BRYAN COUNTY MEGA SITE SOUTH ACCESS ROAD

**T&H PROJECT NO.
J-25503.0004**

ADDENDUM NO. 2

December 6, 2022

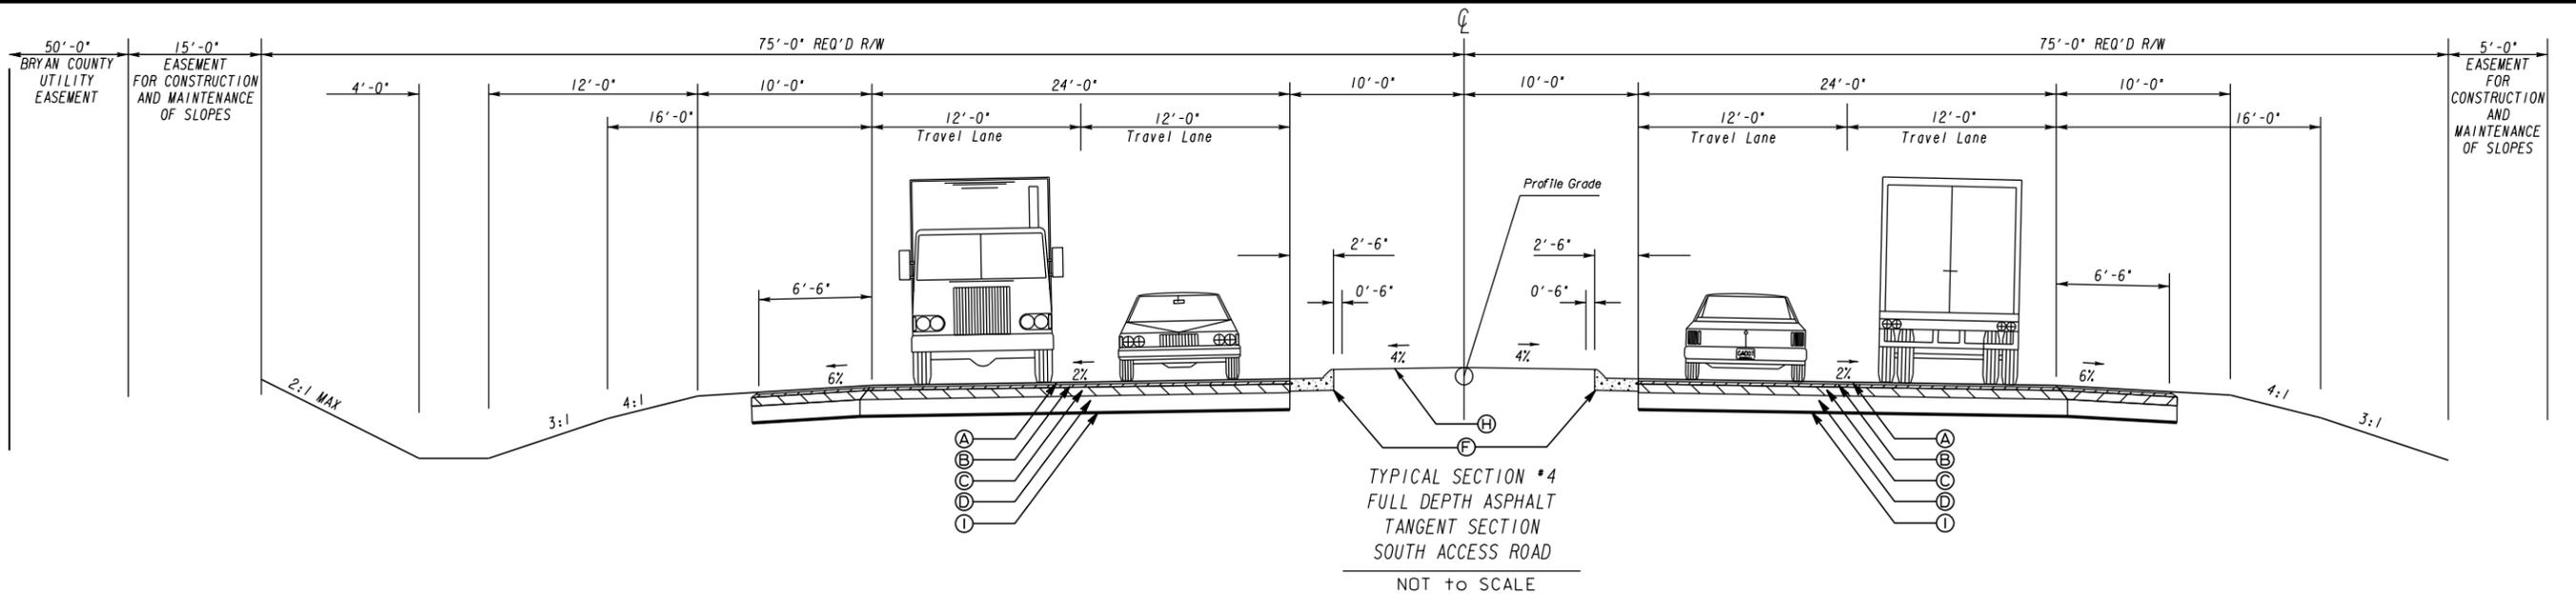
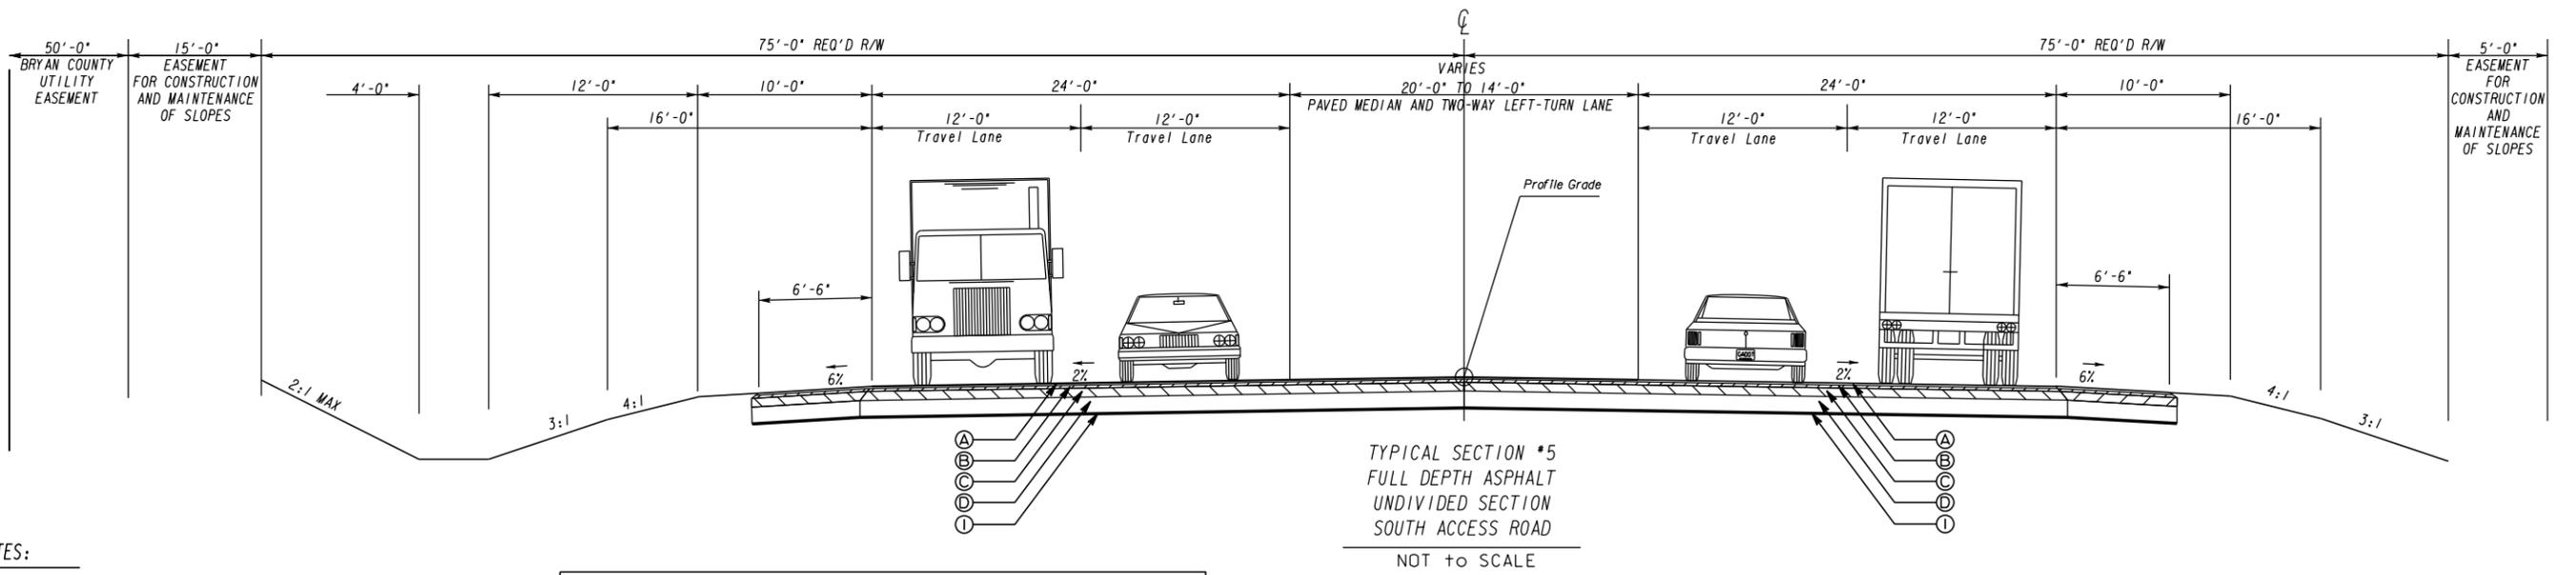
Question 2: I noticed in the report from Terracon that they are suggesting the use of geogrid to be BX1100 as compared to the geogrid labeled on the "Typical Sections" drawing as BX1200. Does this mean that the road base will contain BX1200 and the suggested use of BX1100 is to be used as an alternative to improving additional subgrade performance as needed?

Answer: The geotechnical report has been revised to show BX1200 geogrid. This geogrid will go below the GAB layer. The revised geotechnical report will be included with Addendum 2.

EARTHWORK CROSS SECTIONS
SOUTH ACCESS ROAD

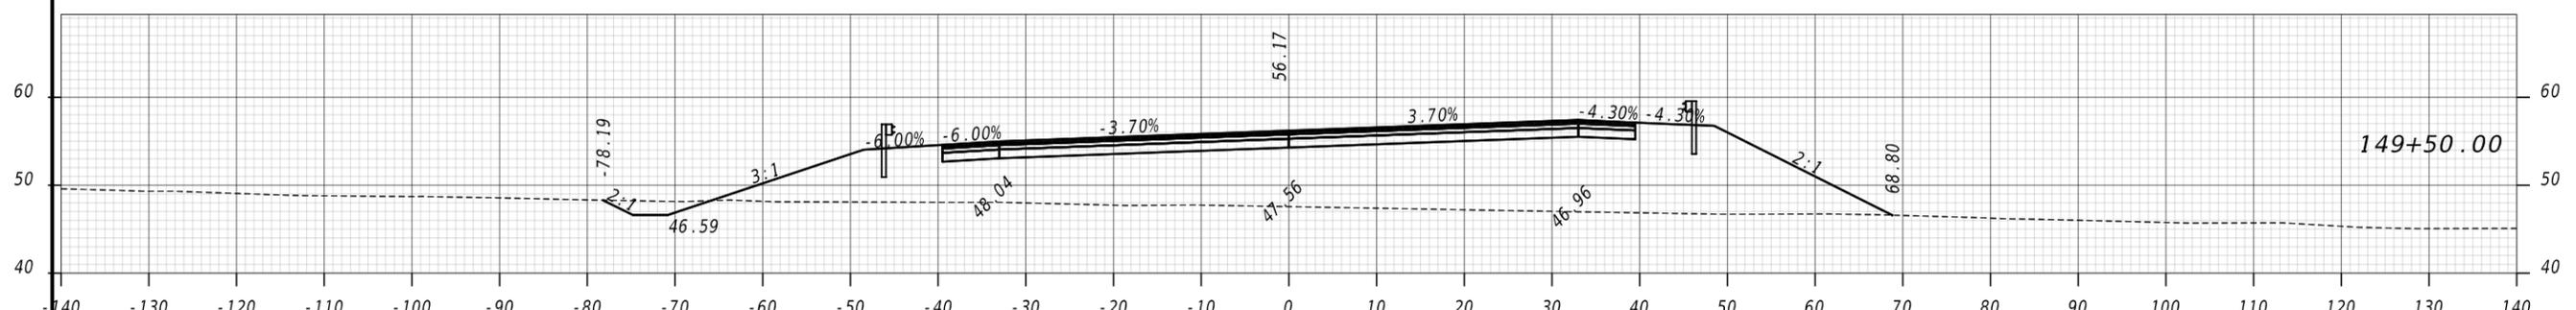
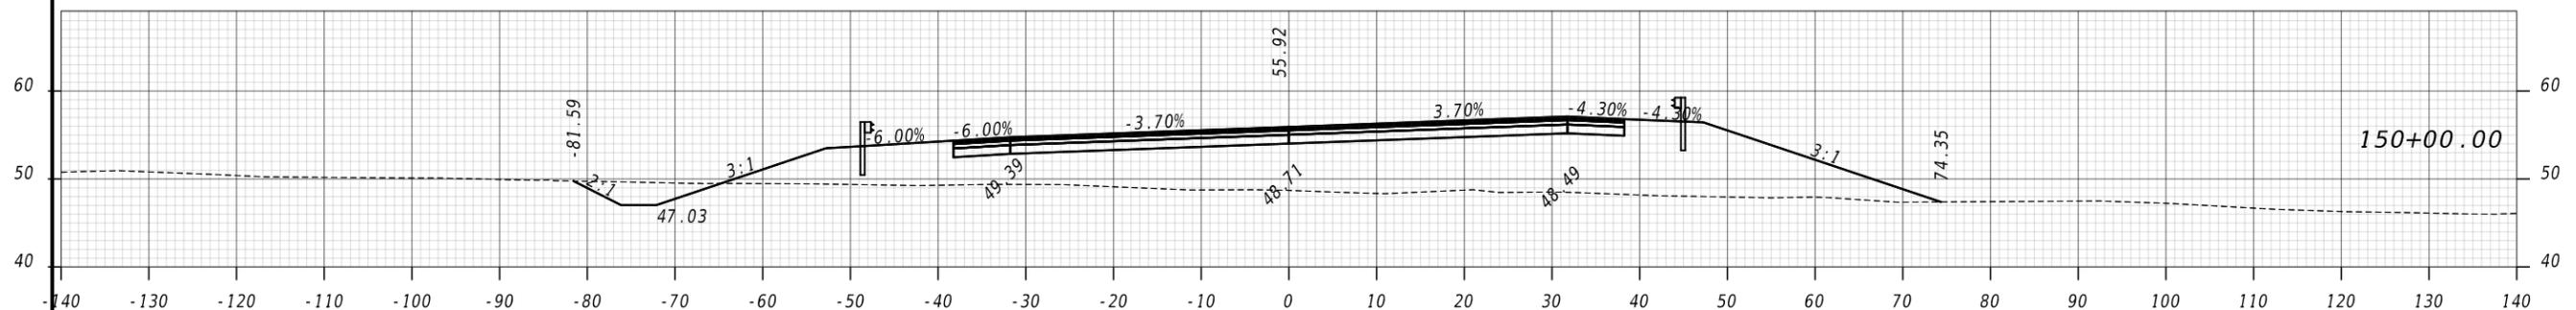
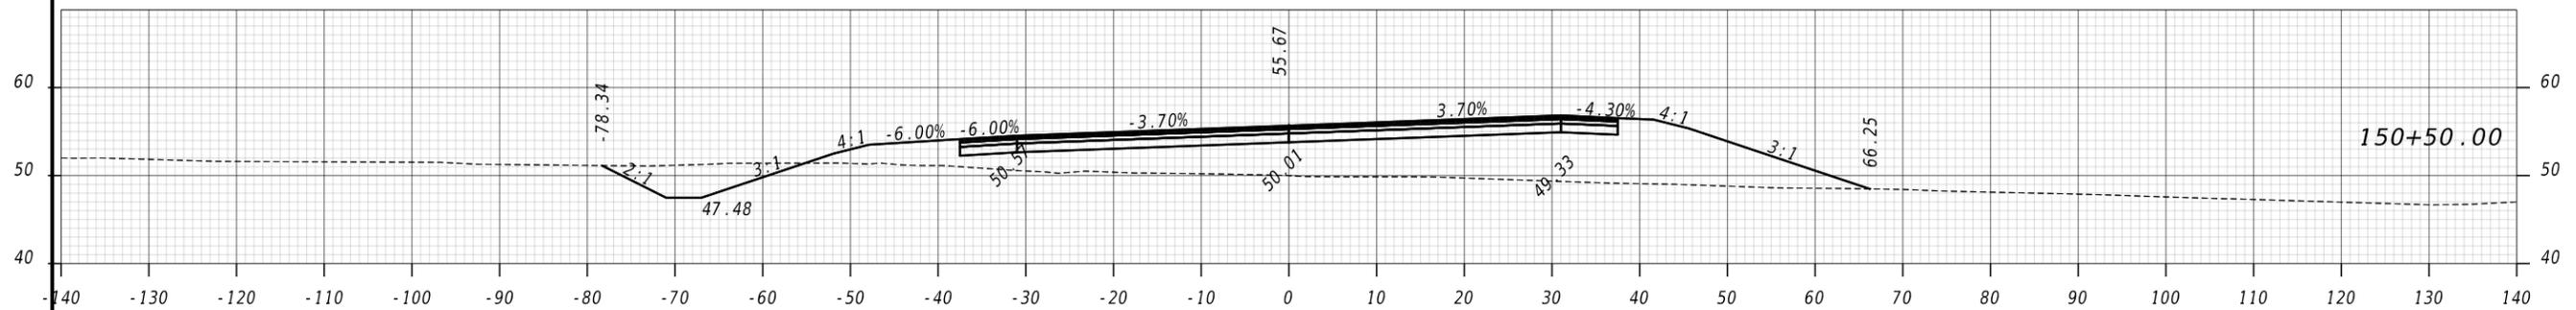
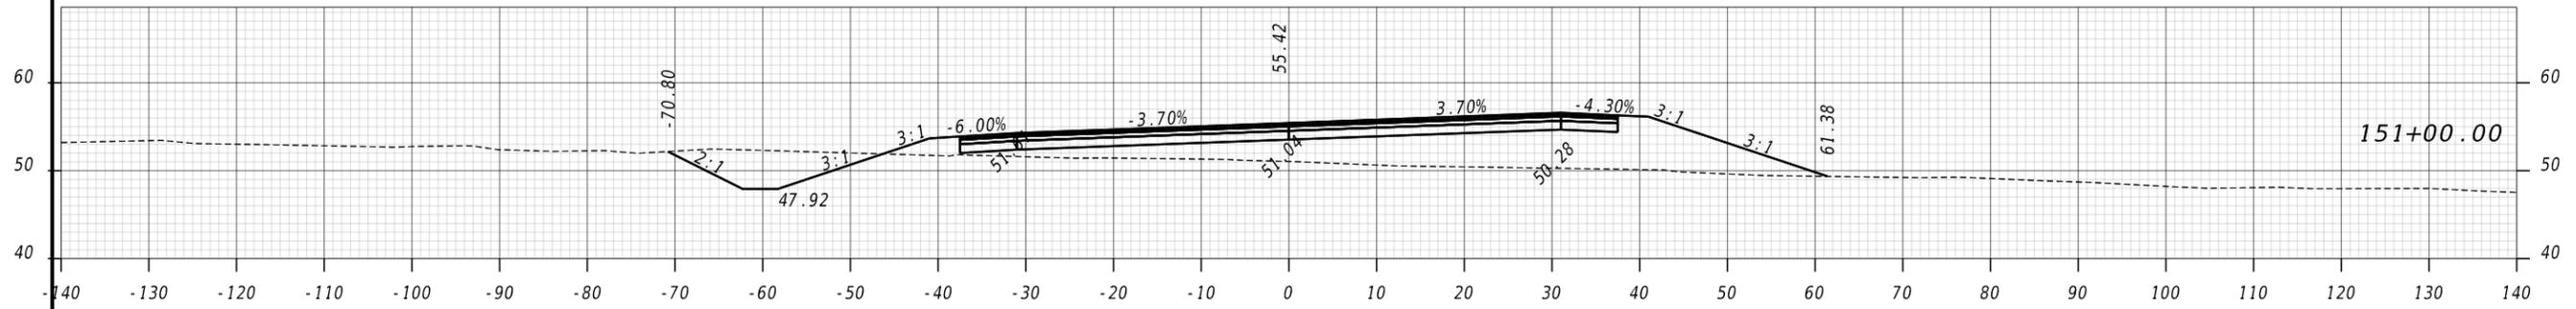
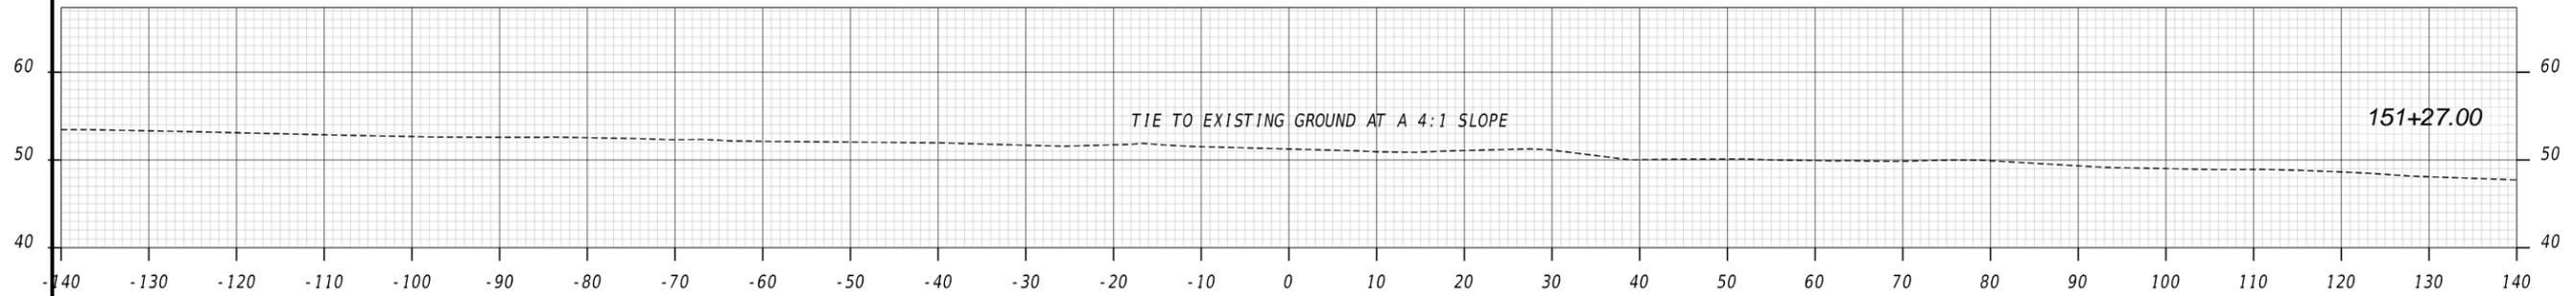
Question 3: The scale bar that is shown on the Cross Section sheets indicates a 1"=20' scale, but the cross sections themselves indicate a 1"=10' scale. Please confirm that the scale of the sections is 1"=10'

Answer: Yes 1" = 10' is correct.

SIGNING AND MARKING PLANS			
SOUTH ACCESS ROAD			
CHECKED:	DATE:	CHECKED:	DATE:
BACKCHECKED:	DATE:	CORRECTED:	DATE:
VERIFIED:	DATE:		
DRAWING No.			26-0001

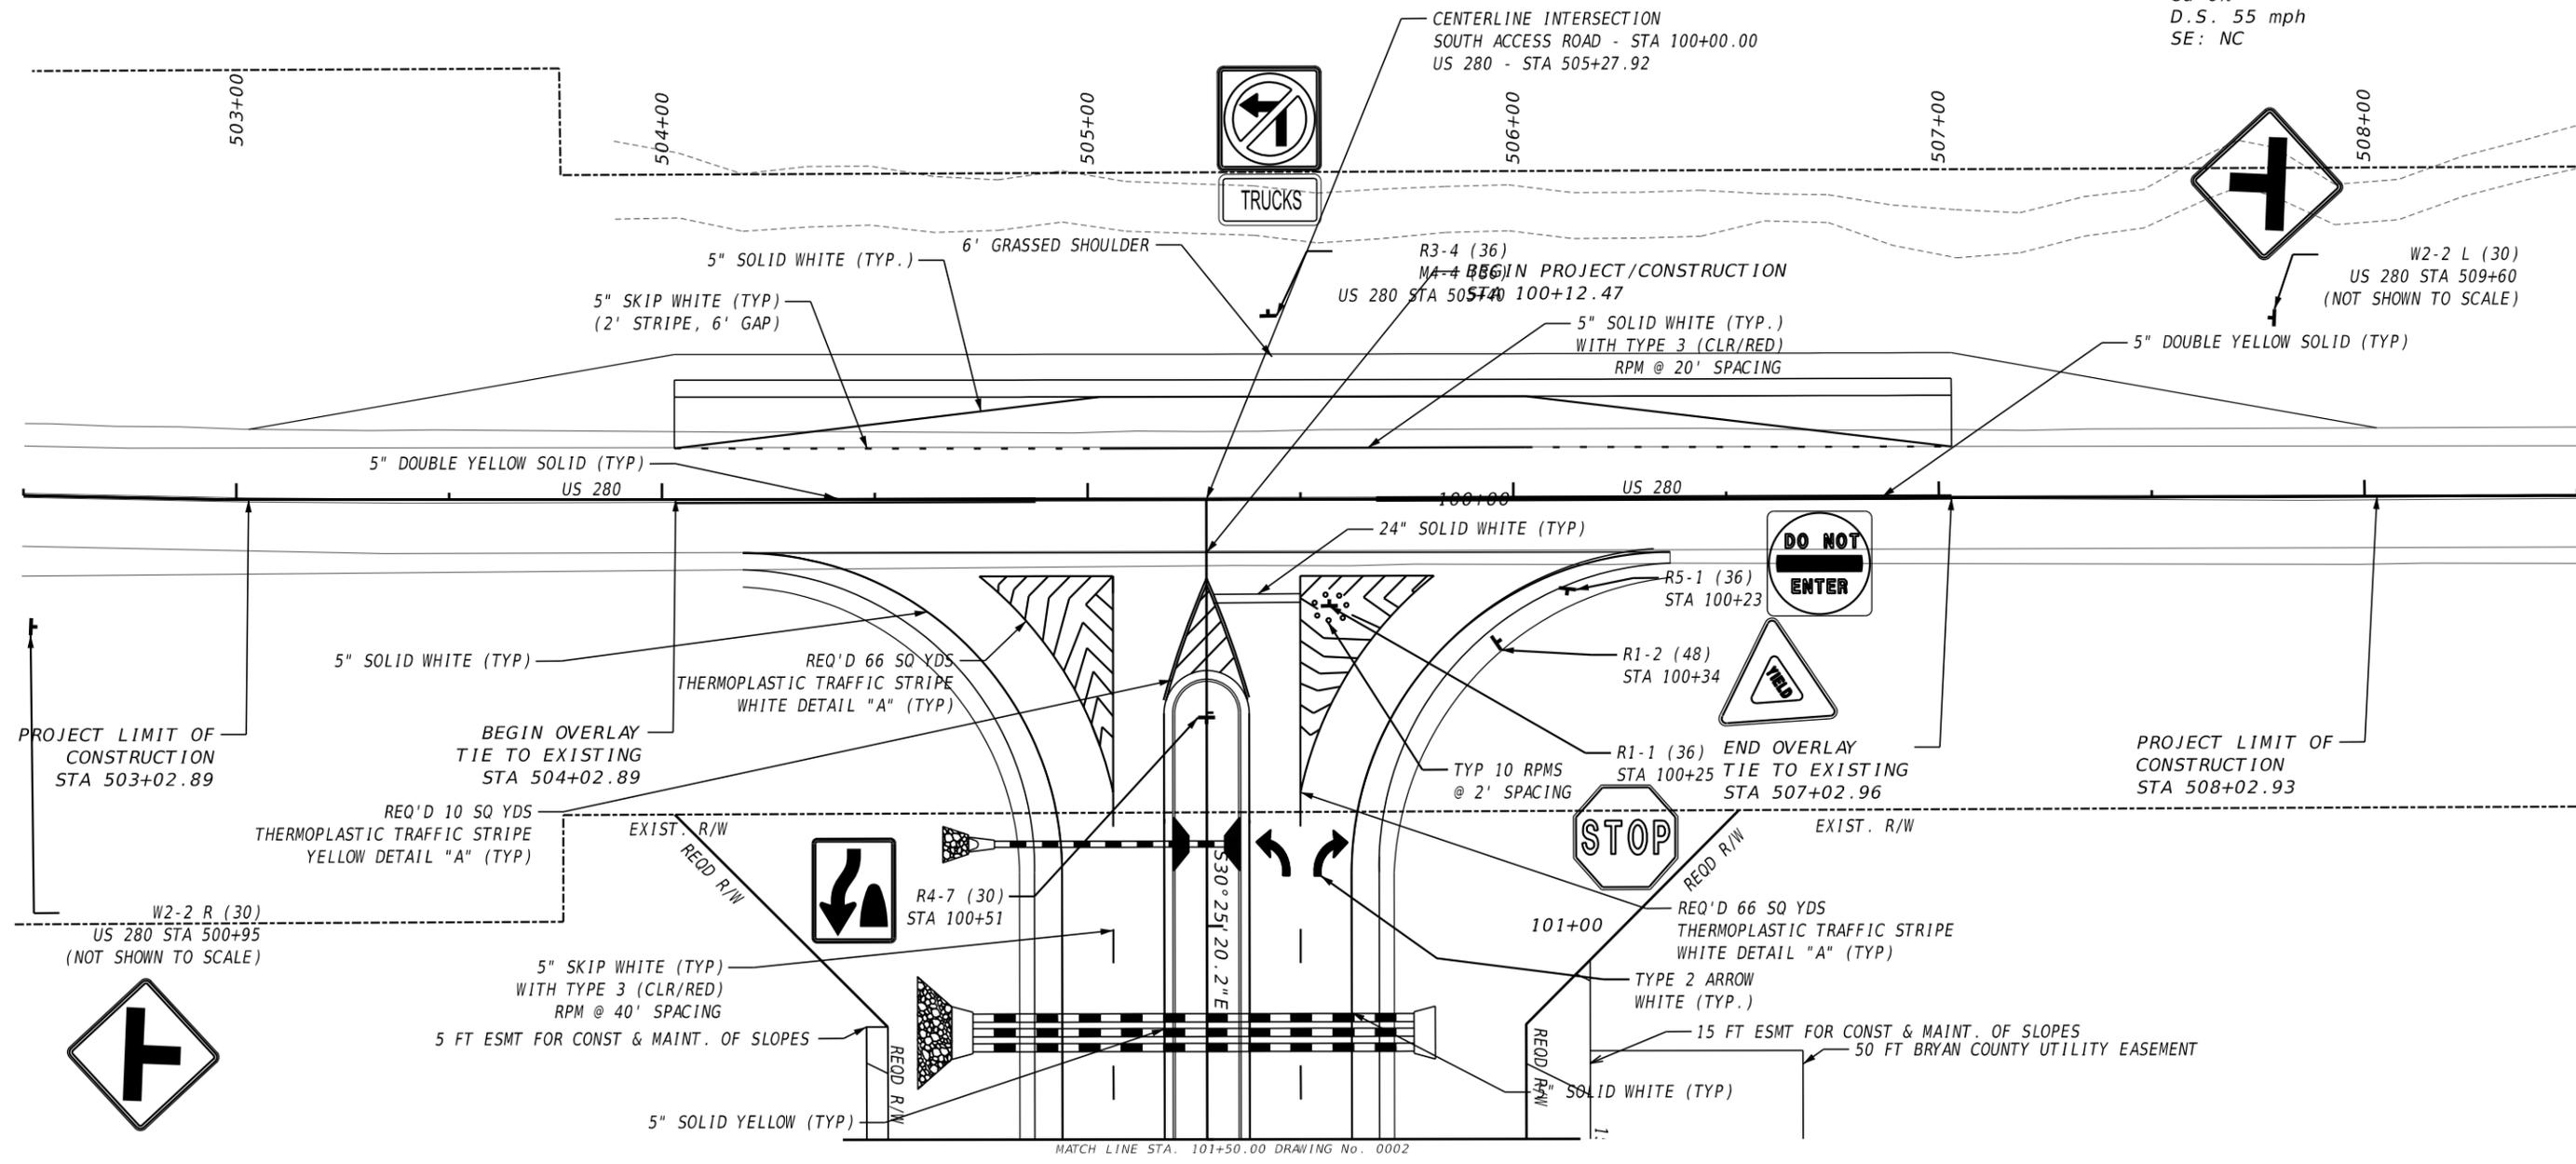
Question 4: We have a hard stopping point at station 149+00. Do you have the grade information to the next station to allow us to calculate the additional fill needed.

Answer: We will revise plans for Addendum 2 to show the transition from the end of the roadway down to existing ground.

PROJECT LIMIT OF CONSTRUCTION STA 503+02.89
